Camelback East Planning December 5, 2017

Planning Commission Hearing Date:January 4, 2018Request From:R1-6 (3.42 acres)Request To:R-2 (3.42 acres)

1. This request is to rezone
3.42 acres located at the
northeast and northwest
corners of 27th Street and
Virginia Avenue from R1-6
to R-2 to allow single-family
attached townhomes.

STREETSCAPE

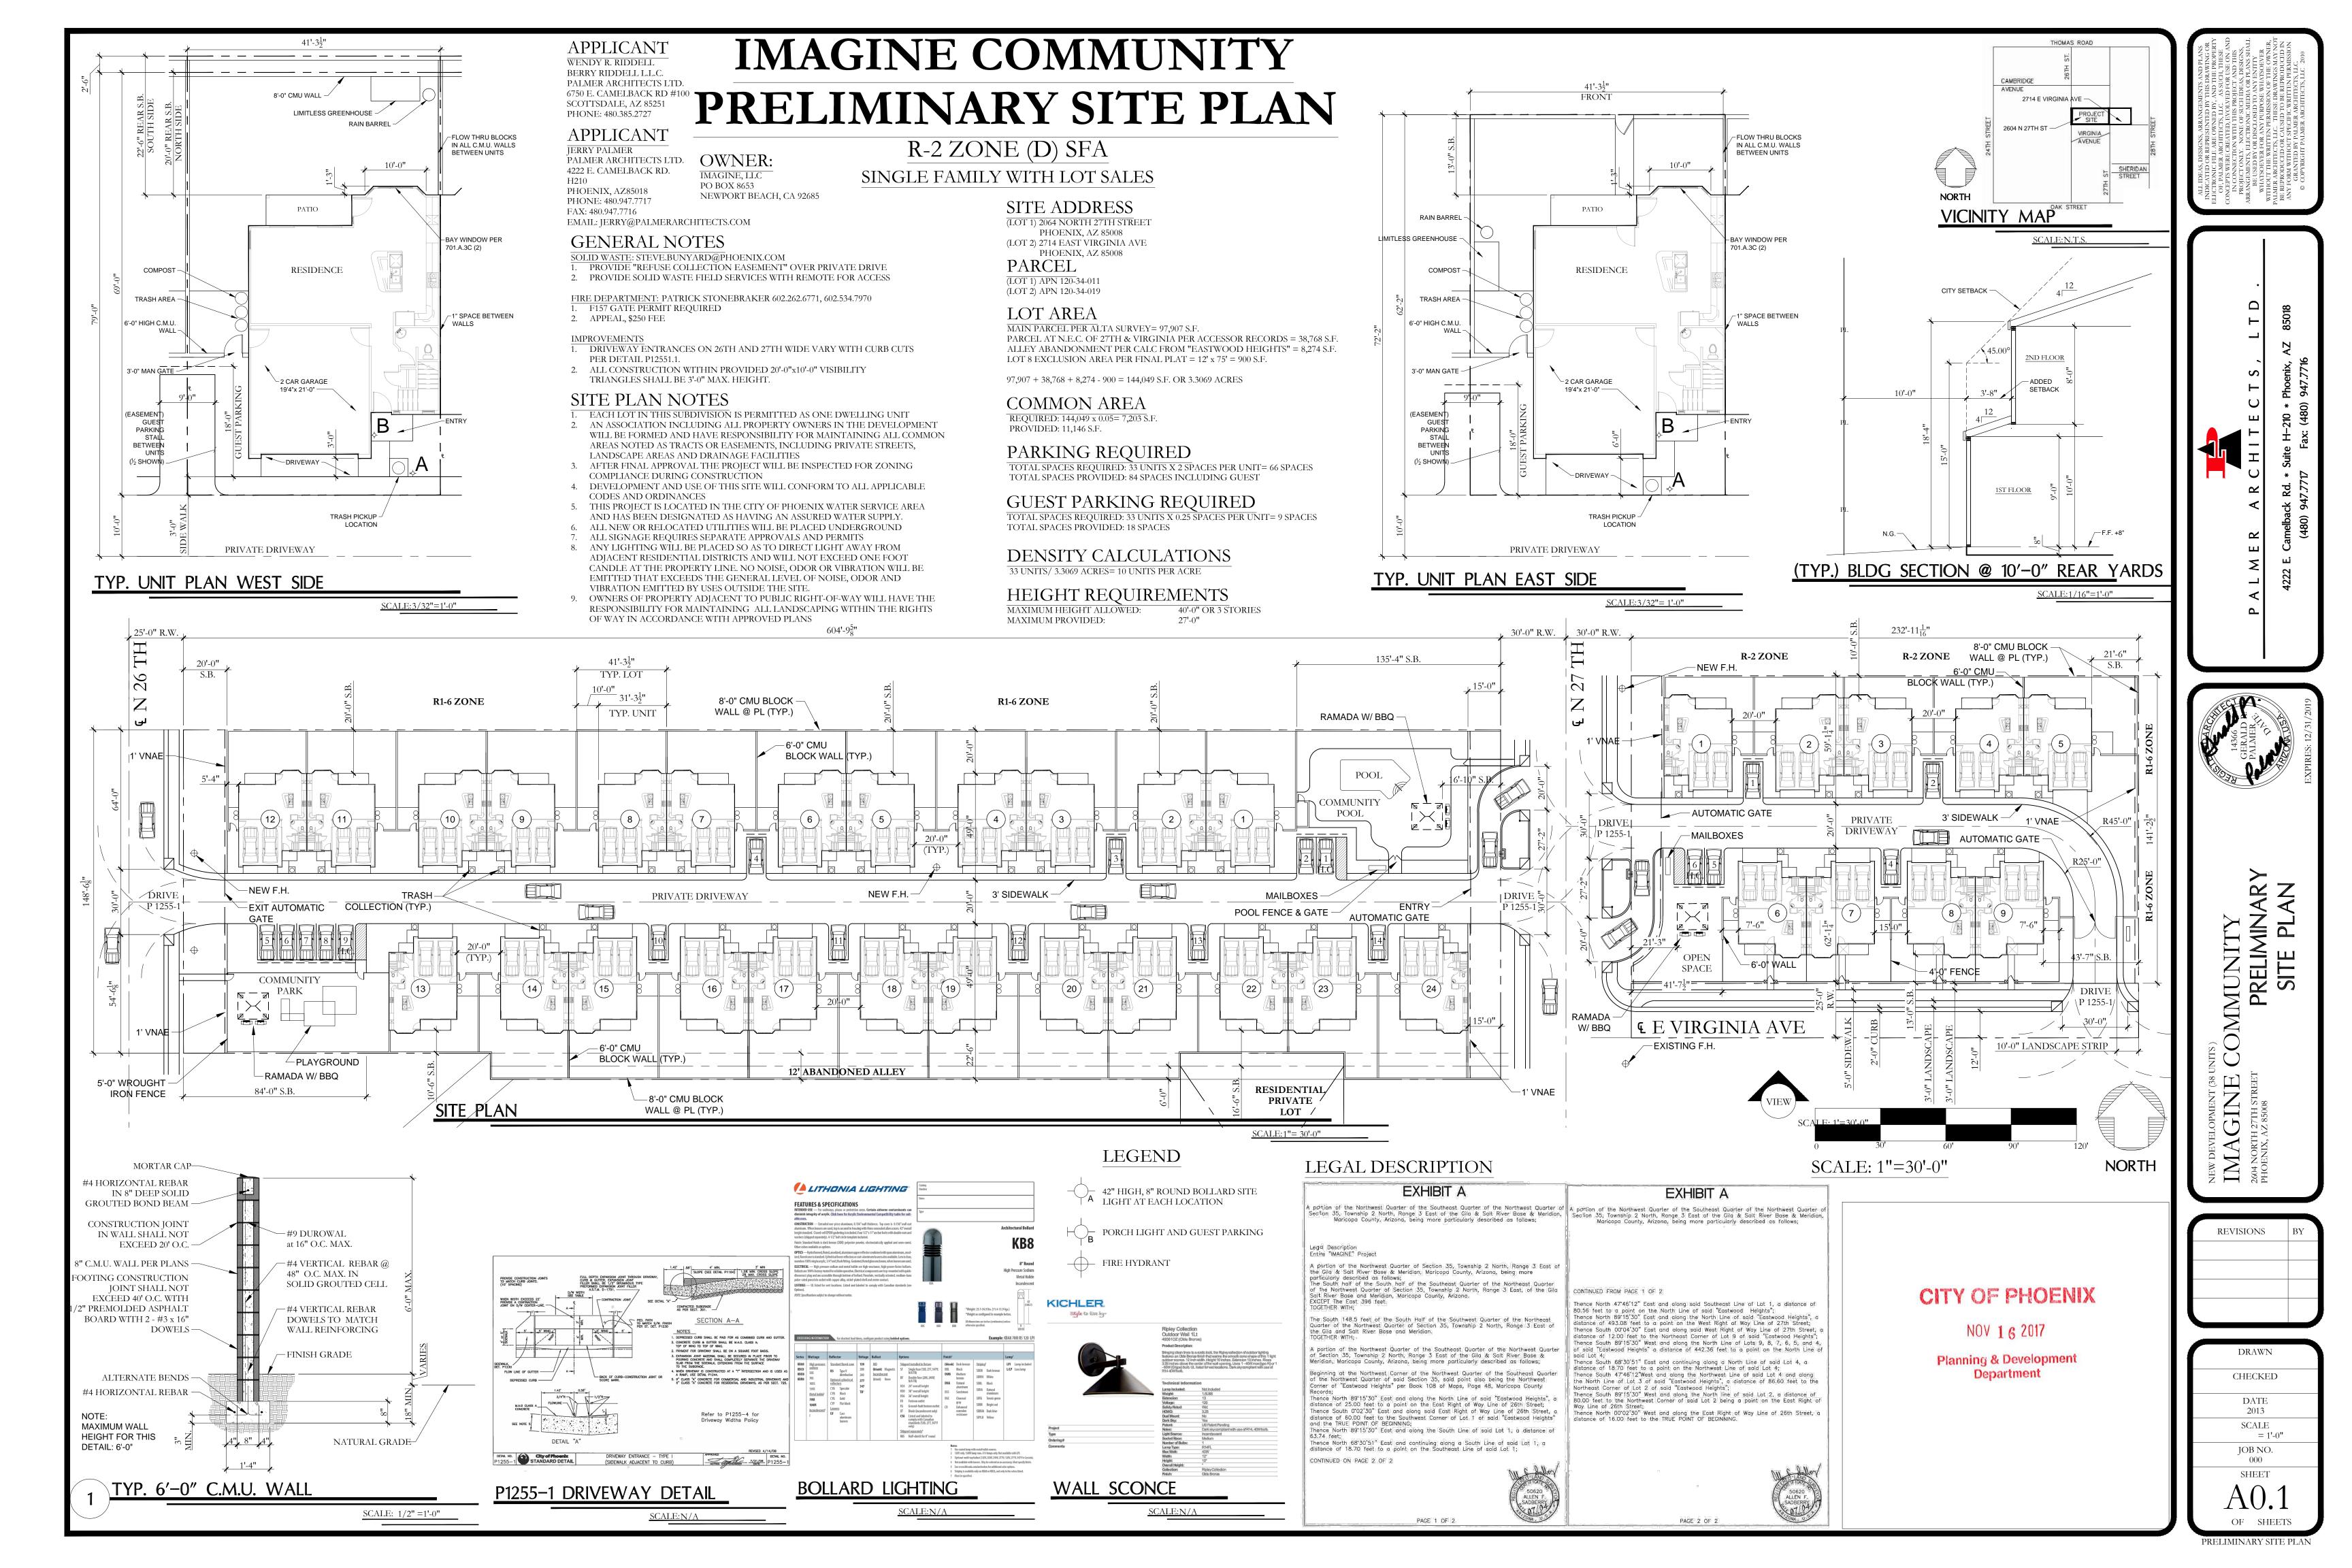
6. The applicant's elevations lack specific details including dimensions for building height, articulation, and architectural detailing. Building design for structures fronting Virginia Avenue will play a key role in engaging the street. Therefore, in order to ensure high-quality development, staff stipulation #1 requires the applicant to submit conceptual elevations to the Planning Hearing Officer (PHO) for administrative review prior to preliminary site plan review. The stipulation outlines specific elements that shall be included in the elevations and reviewed by the PHO including variation in standard plans, provision of covered porches, exterior detailing, articulation, and architectural features.

- 1. Conceptual elevations shall be administratively approved by the Planning Hearing Officer prior to Planning and Development Department preliminary site plan approval for rear elevations, elevations fronting onto Virginia Avenue and elevations that side onto 26th Street and 27th Street with specific regard to:

- a. Provide at least three standard plans, each with distinctive elevations for each standard plan within the subdivision.
 - b. Covered porches a minimum of 60 square feet in area at a depth of at least six feet shall be provided in the front façades of the homes in the subdivision.

- c. Provide exterior detailing on all elevations visible from public streets and rear elevations, such as recesses, pop-outs, accent materials or corbels.

- d. All architectural pop-outs shall be a minimum depth of two inches.
 - e. All window pop-outs and window enhanced detailing (shutters, brick, concrete, etc.) shall be placed on all four sides of the building.

- f. For every 20 linear feet along the rear elevation there shall be a relief in massing of a minimum of 2 feet.
 - g. A trellis feature shall be provided along the sides of the garage doors with climbing vegetation. Such plant material shall be a minimum of 5gallon in size.

- h. Coach lighting shall be provided on both sides of the garage doors.
- i. Decorative garage doors shall be standard and be compatible with the architectural styling.

- j. Provide garage doors with windows, raised or recessed panels, architectural trim, and/or single garage doors.
- 2. The unit count shall not exceed 24 units on the western portion (west of 27th Street) and 9 units on the eastern portion (east of 27th Street).
